Subject: CTI Knuckle Options for MFS73 and FL941

Models: MFS73 AND FL941 Non Drive Front Steer Axle

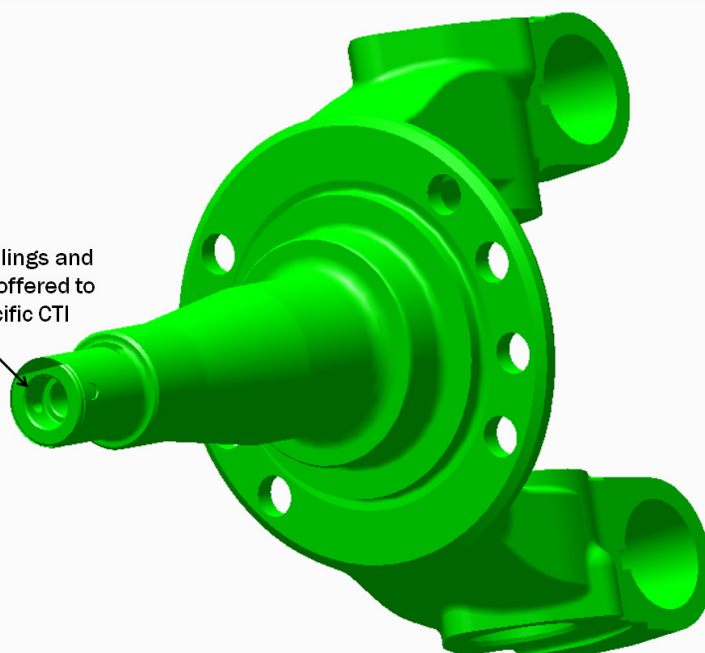
The drilling and tapping of the knuckles for CTI systems is specific to each system, and the appropriate knuckle is required to suit the axle model and brand of CTI being fitted.

Different drillings and threads are offered to suit the specific CTI system
